# UNITED STATES PATENT AND TRADEMARK OFFICE

APPLICATION NO.	FILING DATE	FIRST NAMED INVENTOR	ATTORNEY DOCKET NO.	CONFIRMATION NO.
10/816,585	03/31/2004	William H. Whitted	GOOGP022	8421
23689	7590	06/18/2007	EXAMINER	
Jung-hua Kuo			PAPE, ZACHARY	
Attorney At Law				
PO Box 3275			ART UNIT	
Los Altos, CA 94024			2835	
			MAIL DATE	
			06/18/2007	
			DELIVERY MODE	
			PAPER

**Office Action Summary**

## DETAILED ACTION

Fig 1

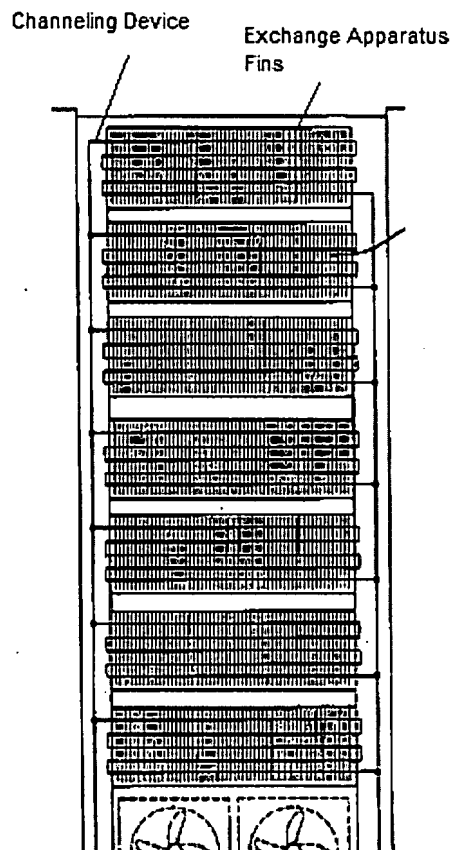
With respect to claim 8, Chu et al. further teaches that each heat exchanger includes a heat exchange fluid channeling device and a heat exchange apparatus in thermal communication with the heat exchange fluid channeling device (See present office action Fig 1 below).

With respect to claim 19, Chu 770 further teaches that the means for cooling air (21) includes a means (As illustrated in the present office action Fig 1 above) for channeling a heat exchange fluid and means (Fins as illustrated in POA Fig 1 above) for channeling the heat exchange fluid extends.

With respect to claim 20, Chu 770 further teaches that the means for heat exchange includes a plurality of heat exchange fins through which the means for channeling the heat exchange fluid extends (As illustrated in POA Fig 1 above).
